Statement of Response to Kildare County Council's Opinion

Finlay Park, Naas, Co. Kildare

Client:	Westar Homes Limited
Project Title:	Finlay Park LRD
Document Title:	Statement of Response to Opinion of Kildare County Council
Project No.:	20175

Figure 2.3: Taking in charge Plan

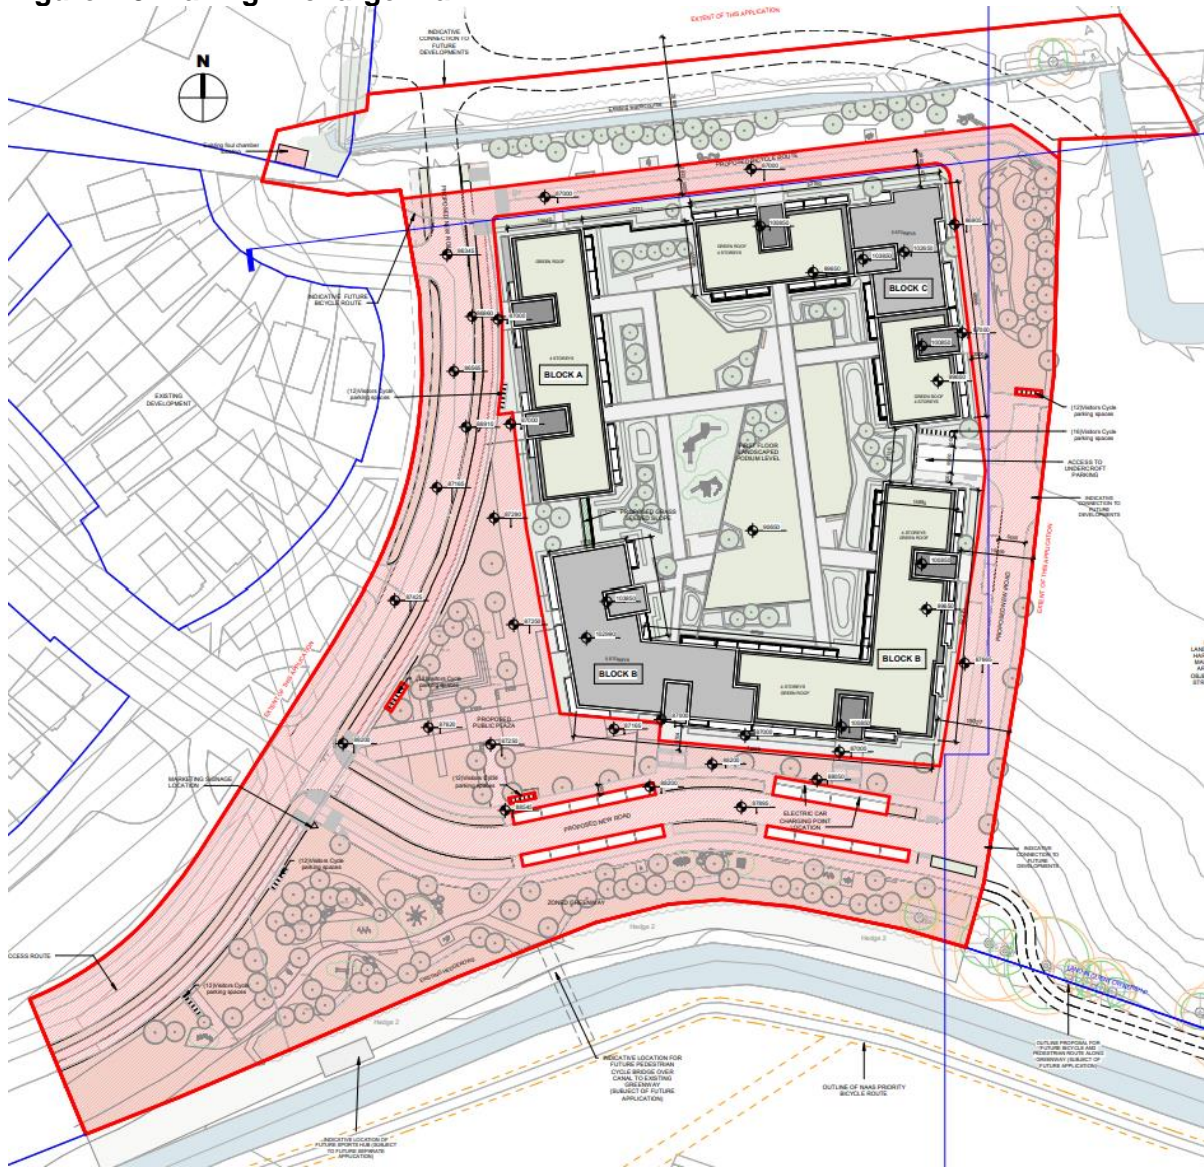
(d) Areas of the development to be taken in charge by the Local Authority omitting the locations of electric car charge points.

Response: We refer the Planning Authority to the C+W O'Brien drawing DR-A-0112 which shows the taking in charge areas (Figure 2.3)

Figure 2.5 Naas Sallins Transport Strategy Preferred Options affecting Finlay Park Site

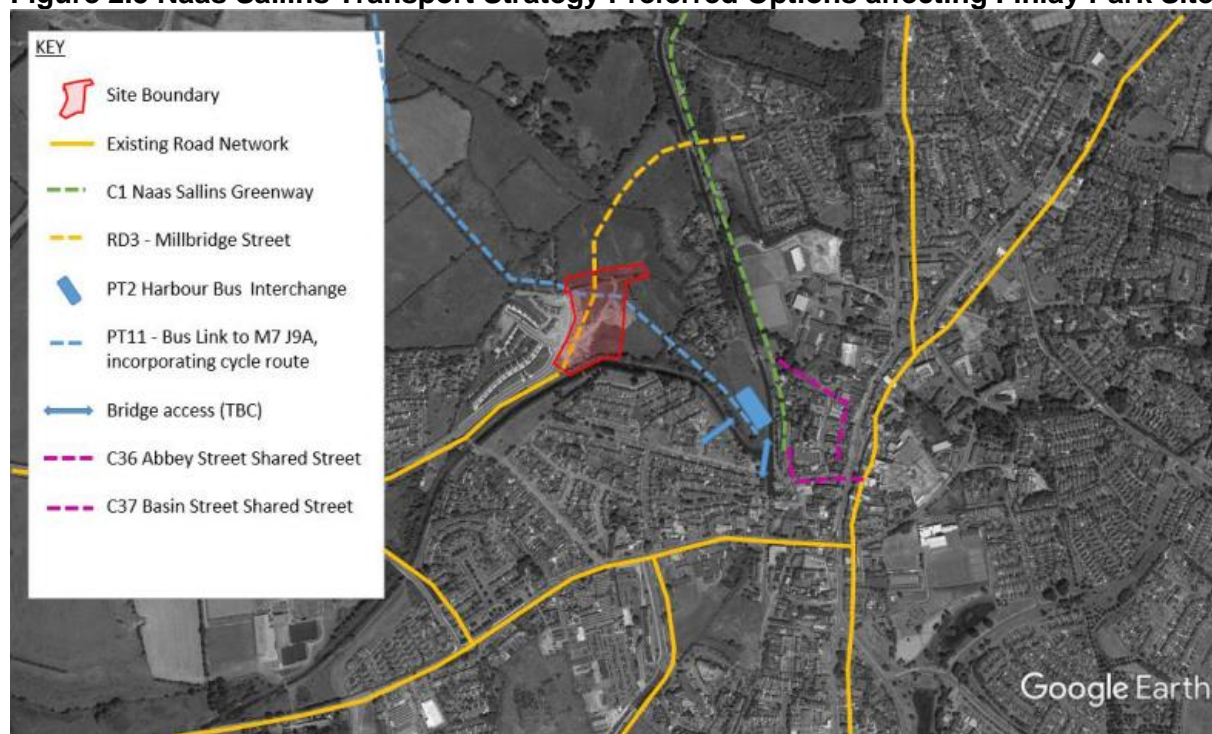
(b) Existing and proposed walking and cycling routes in Naas. The applicant will be required to have consideration to the Naas Sallins Transport Strategy and the Naas Sallins Greenway project.

Response: Section 3.6 of the MMP includes detail in respect of the Naas Sallins Transport Strategy. The Naas Sallins Transport Strategy (2020) identifies a multi-modal package of preferred measures, which are earmarked to be delivered in the short, medium and longer term over the next ten years (Figure 2.5). The site is not reliant on these but will benefit from the interventions.
